# GEORGETOWN UNIVERSITY TOWNHOUSE EXTERIOR REPAIRS

OLD GEORGETOWN BOARD SUBMISSION – JANUARY 2023

Renovations to  
3612  
O St. NW  
Washington DC.  
20007

Re: Response to Comments:  
Project Address: 3612 O St. NW

PHOTO REFERENCES

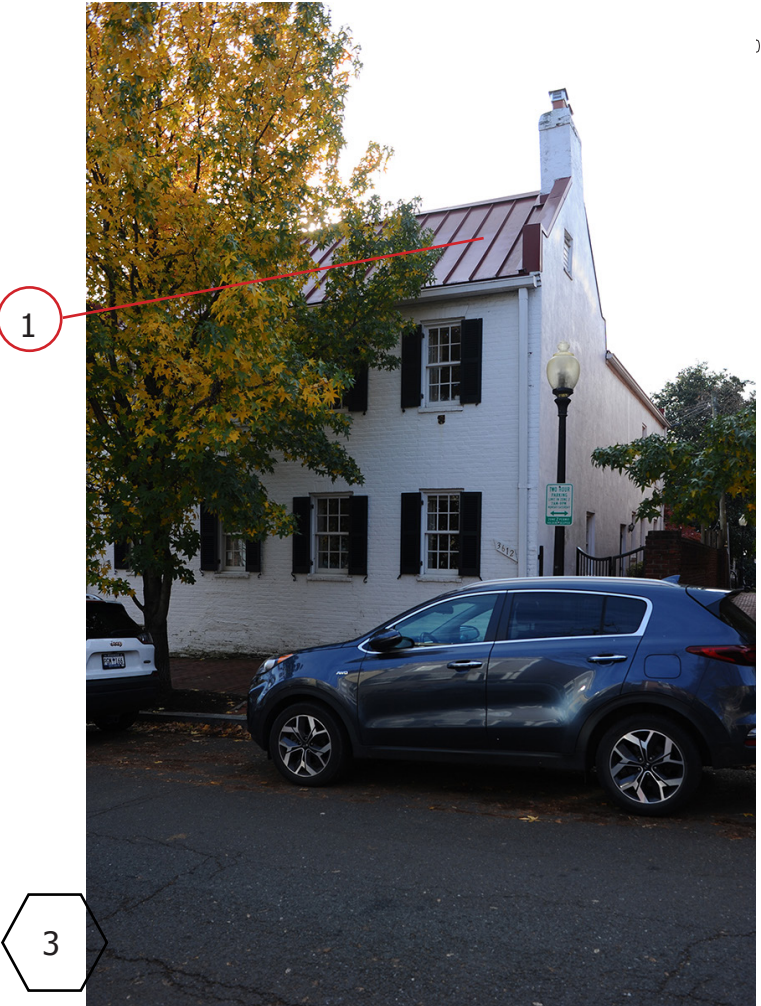
2. The drawings indicate the brick wall along the side property line is to be repaired. I would suggest that you include more representative photos of the wall in your submission. This wall looks to have a good bit of deterioration, likely from incompatible mortar repairs, water, and salting of the sidewalk. I am just wondering to what extent this will be a repair as opposed to rebuilding. Have you confirmed that you can find bricks to match the existing? Will the wall be 100% repointed? Please specify a lime-based mortar without Portland cement that is soft enough to be compatible with the soft brick of the wall. Limeworks is one such company that still makes these softer mortars for historic applications, although you can use any brand or company you wish.

One question I had was regarding the alley wall at 3612 O Street. The wall I was referring to was the free-standing brick wall shown on AP2 (not the building wall). The notes say replace damaged bricks, reset cap, repoint mortar joints. What is the cap that is to be replaced and with what material? I also highly recommend specifying a lime-based mortar, given the condition and age of the bricks. Do you have a sense as to how much of the wall will need to be rebuilt?

*Additional photographs of the side (alley) wall show the wall to be in reasonably good repair. The chimney seems to be the location with the most brick damage. We do not propose extensive rebuilding or repointing. We will contact a masonry supply company to determine if a matching brick is available.*

*The bricks in the wall are in reasonable condition with very few cracked units. There are areas of missing or damaged mortar. The termination pillar for the wall seems to have been struck by a piece of equipment that dislocated the top 6 courses of brick-this is the 'cap' to which I referred.*

*I have added photos to further describe the corrective work we are proposing and noted use of a lime-based mortar.*

STANDING SEAM  
PANEL DETAIL

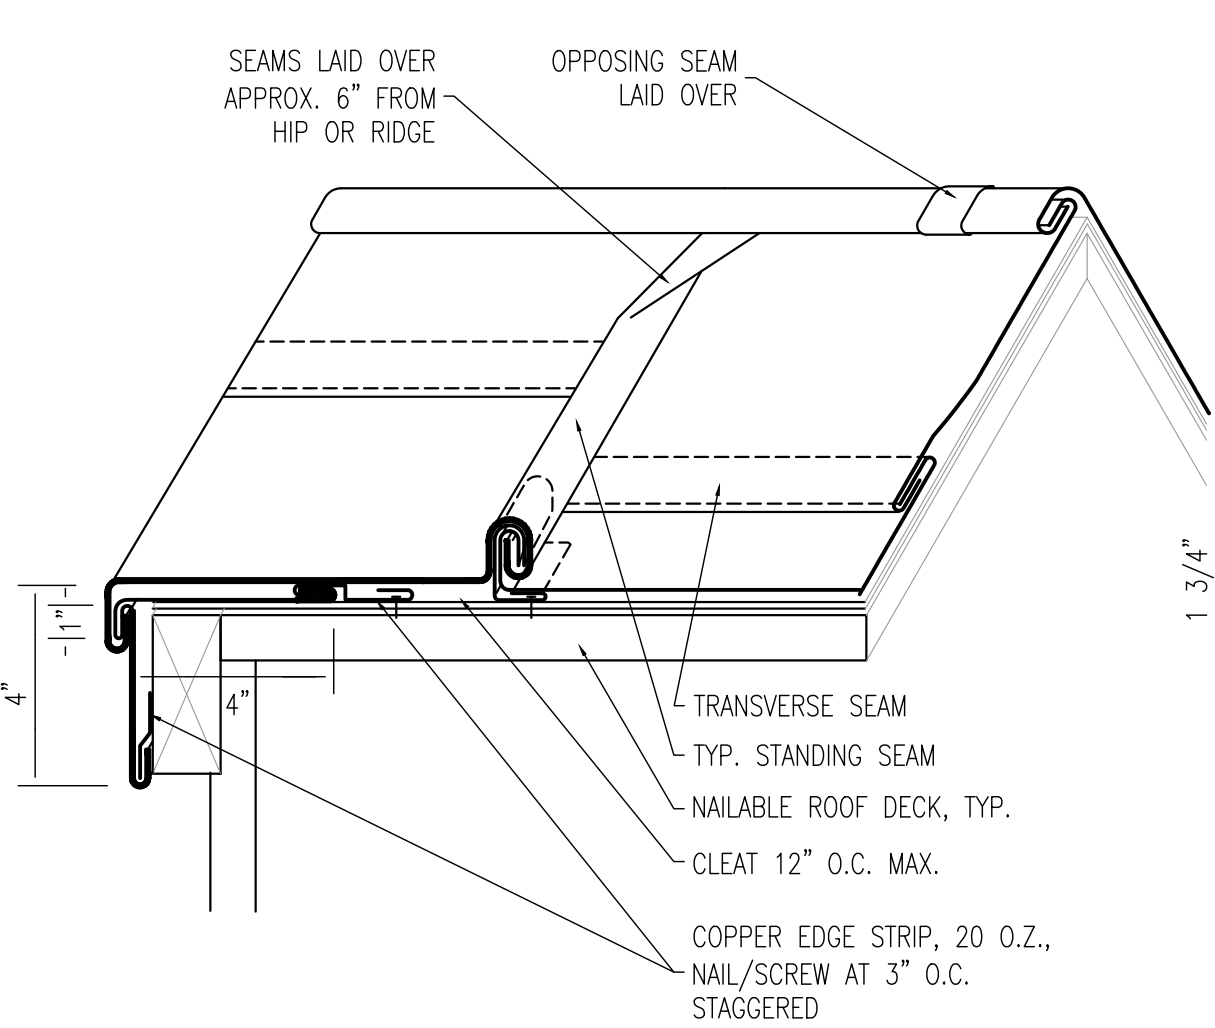
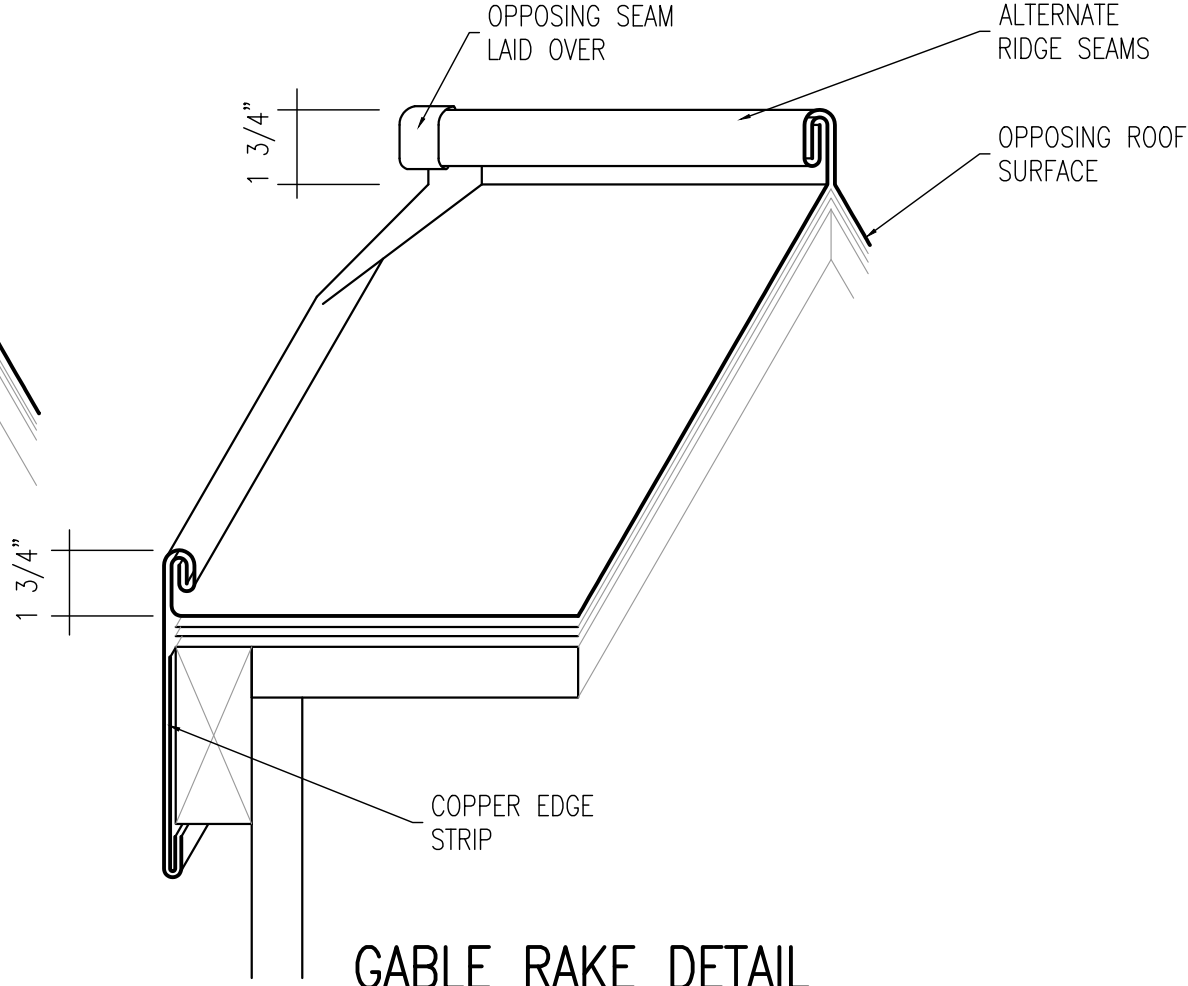
1. Please provide existing and proposed pan width and seam height dimensions of the existing roof.  
*Information regarding the seam height and panel width has been added to the drawings.*
